Horizon PCB Review: X2A

dwc_ap_lpddr4x_multiply_tsmc16ffc18 : LPDDR4/4x,DDR4 at 4266MT/s

Synopsys SIPI Team

31/03/2020

Signal routing

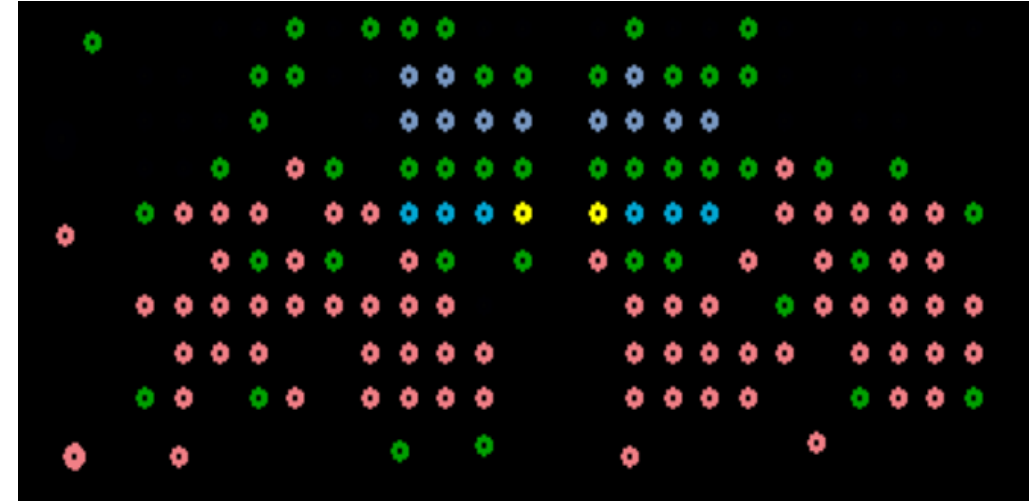
- Signals should have a proper reference plane: routing over plane gaps and/or plane splits should be avoided. Routing over splits can lead to,
 - Reflections due to impedance mismatches over the splits.
 - Excessive crosstalk due to absence of proper reference.
 - DQ/DQS are double data rate signals and usually have smaller timing margins and it's preferable to route them over the VSS planes where there are no splits.
 - ADD/CMD/CTRL are single rate signals and can have a combination of both VDDQ and VSS layers as reference. Clock also has to be routed on the same layer since it's synchronous with ADD/CMD/CTRL group. However a sign off on this should be done only after simulation run and quantifying whether the impact of the split/noise is acceptable on the eye margins.

Reference vias

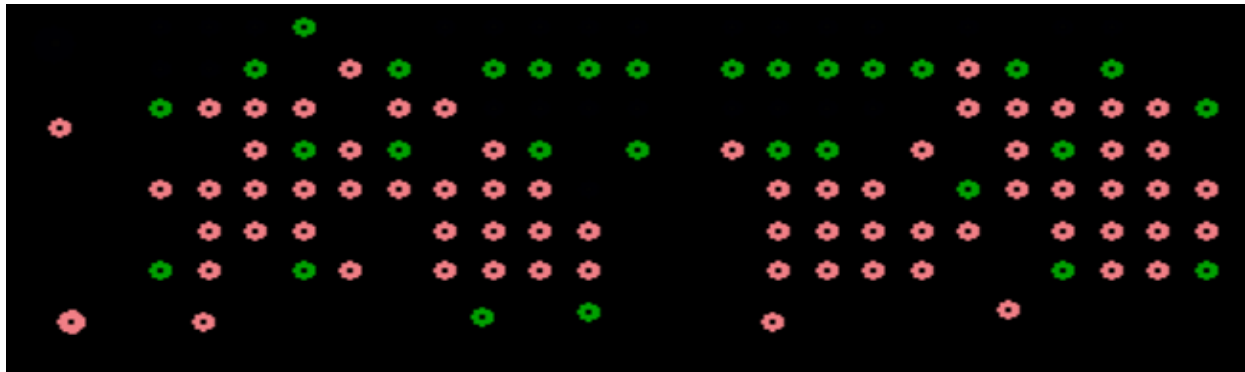
- The GND vias can be more uniformly distributed around the signal vias to have a proper return path and minimize crosstalk.
- Recommended to prioritize DQ Signal to GND Via distribution.
- Need to run simulations to quantify the impact in the current configuration.
